CONTRACT ADDENDUM NO. 2

NOTICE TO ALL BIDDERS FOR THE:
Topeka & Shawnee County Public Library
Tech Services Renovation
HTK Project No.: 2001.01-006

1D101 Partial Demolition Plan, not to scale

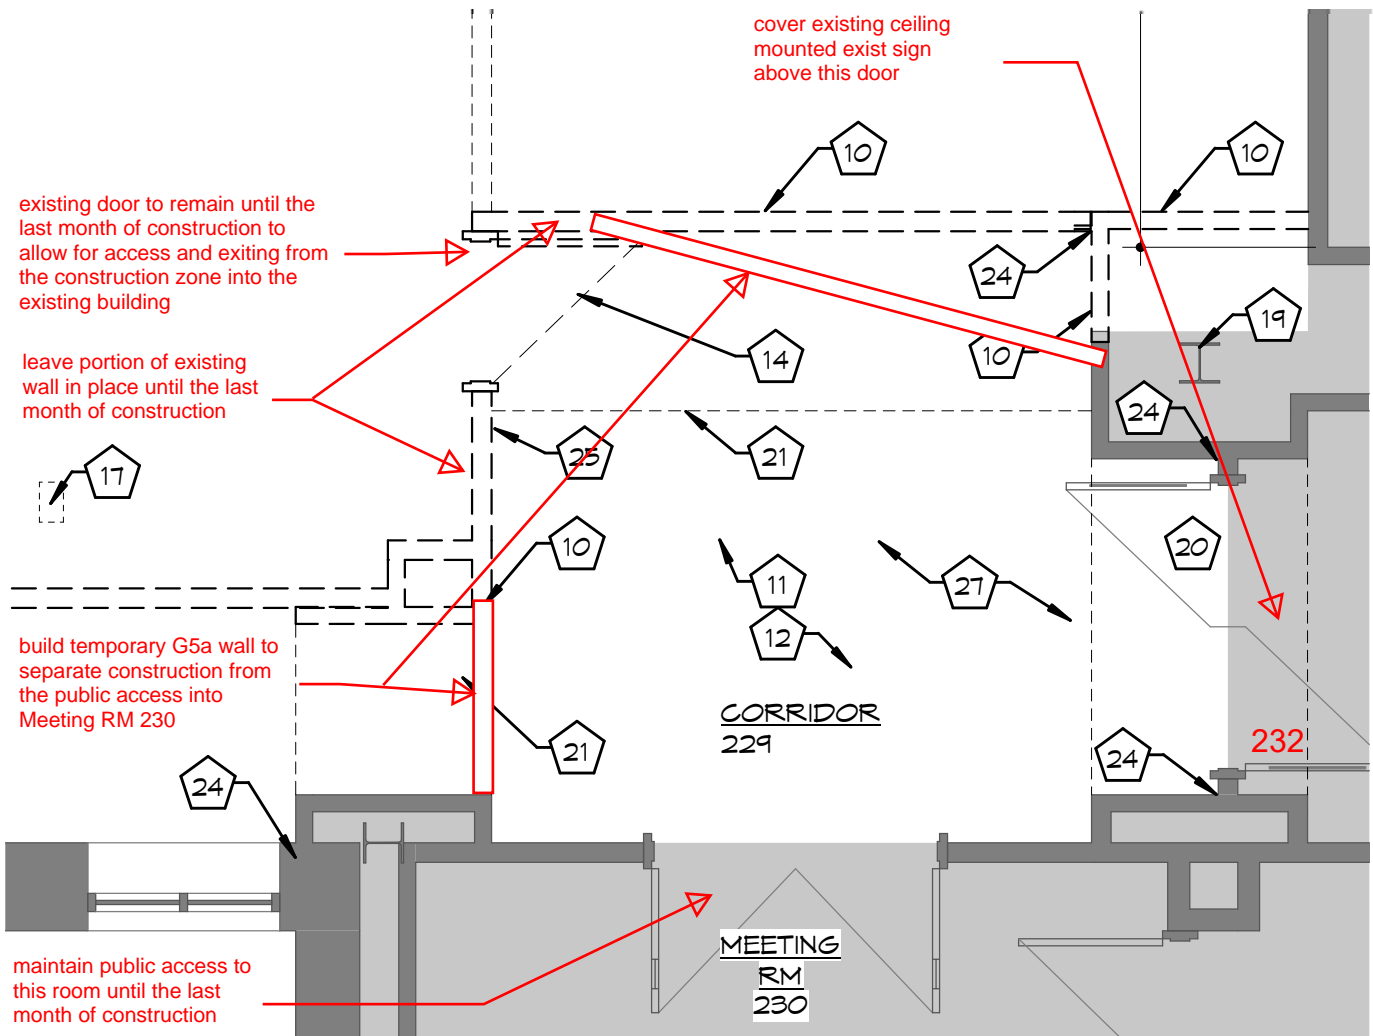
1. The temporary wall and fire watch requirements outlined in Demolition plan note 27, shown on D101, and referenced in the Prebid meeting notes issued in Addendum 1 will not be required. Instead, revise demolition plan note 27 to read: "During construction, cover the existing ceiling mounted exit sign above door 232 (labeled on A101). Maintain access to Meeting Room 230 (labeled on D101) until the last month of construction by leaving the existing door out of the tech services space and extend the existing wall to the south and east. In the last month of construction, these temporary walls can be removed and the tie in between existing and new construction can be completed." See the partial demo plan on the next page for modifications.
